PLANNING COMMISSION MEETING AGENDA REGULAR MEETING

May 10, 2011

SUBJECT: PRELIMINARY SITE PLAN REVIEW (File Number SP 343 D) – Proposed Site Improvements, North side of Big Beaver, West of Crooks (1500 W. Big Beaver), Section 20, Zoned O-1 (Low Rise Office) District

SUBJECT: PRELIMINARY SITE PLAN REVIEW (File Number SP 968) – Proposed Suburban Cadillac Buick, North of Maple, West of Crooks (1810 Maplelawn), Section 29, Zoned M-1 (Light Industrial) District

SHEET
Engineering Site Plan

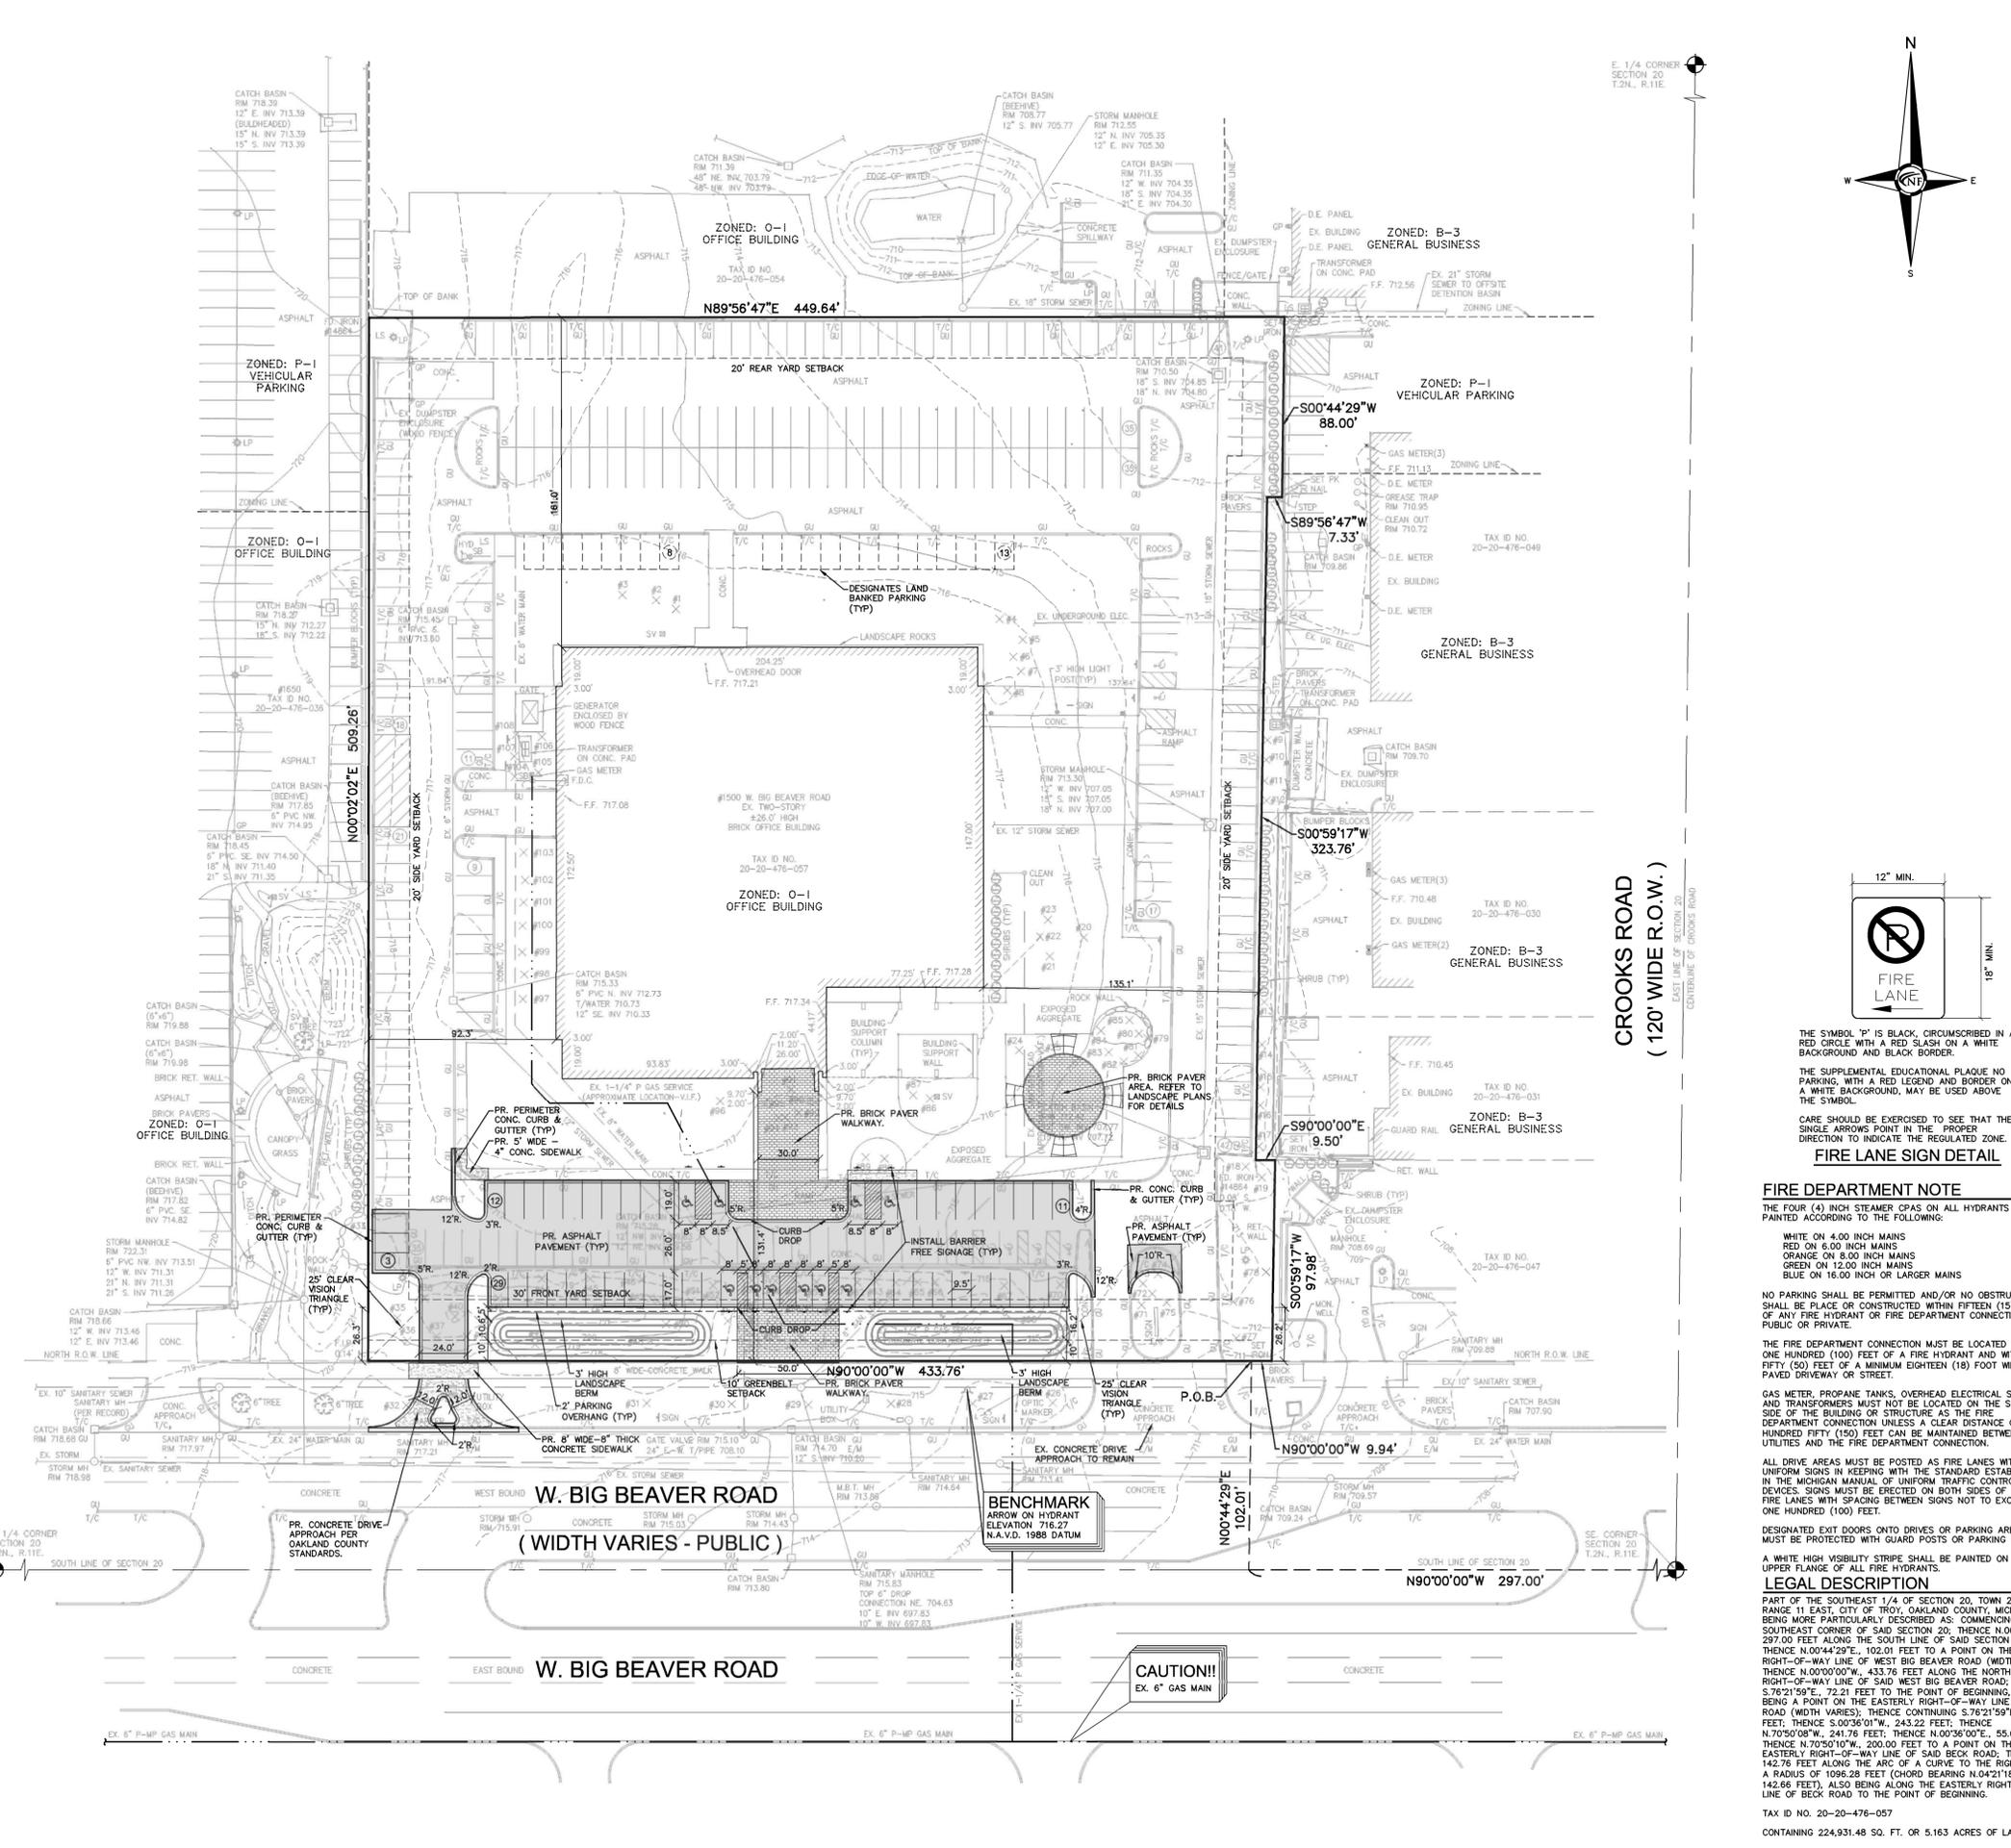
The new parking area would impact an existing berm and many existing trees. The site plan application includes a survey which demonstrates that the site has 91 existing trees, 51 of which are to be removed. One of these trees is dead. The landscape plan shows that 33 new trees will be added to the site, along with extensive shrubs and groundcovers. The site plan also includes a new 3-foot berm along the front parking area, in accordance with the design recommendations of the Big Beaver Design Guidelines, to replace the larger berm displaced by the new parking.

Project
 14 March 2011
 Full Master Floor Plan

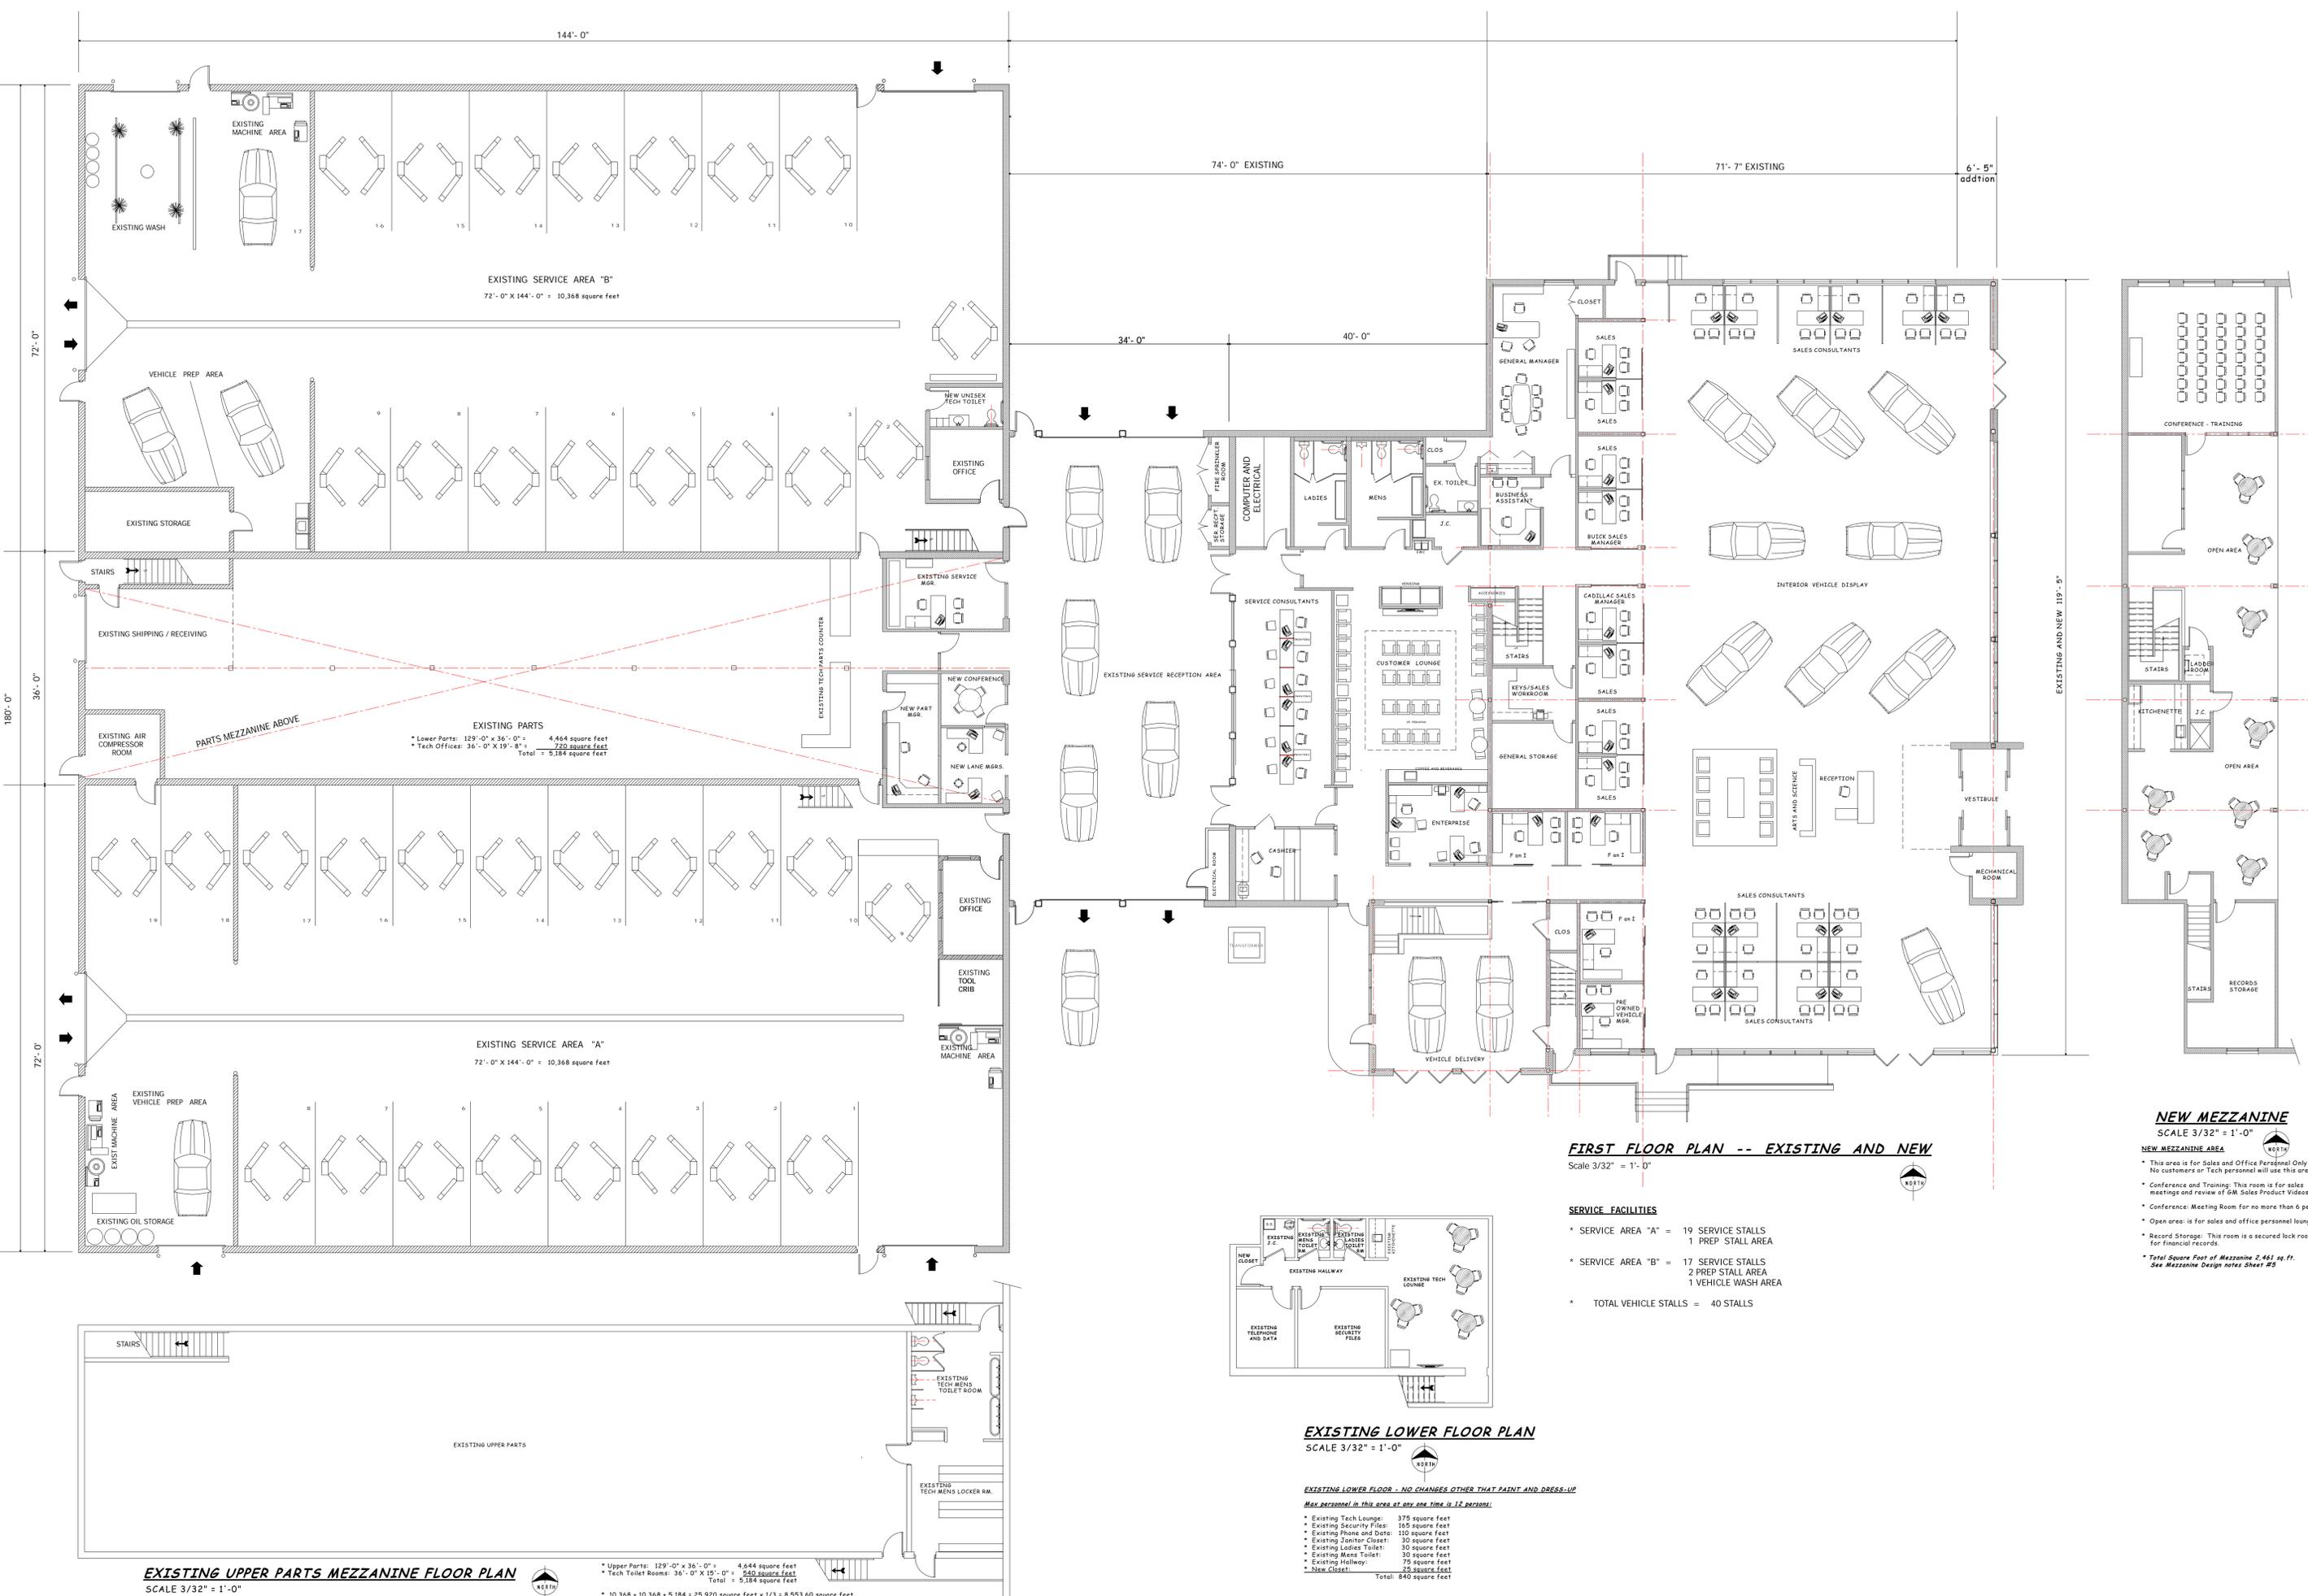
It is unclear how the specific provided sales floor area calculations were derived. The proposed main sales floor area is not detailed with an area calculation; however, the new proposed mezzanine is so detailed. Given the large excess of available parking, we do not object to the plan. However, a revised plan should further detail how the specific sales floor area of 8,610 square feet was derived, and should explain if the mezzanine area was included.

Items to be Addressed: Provide additional detail about how sales floor area calculation was derived.
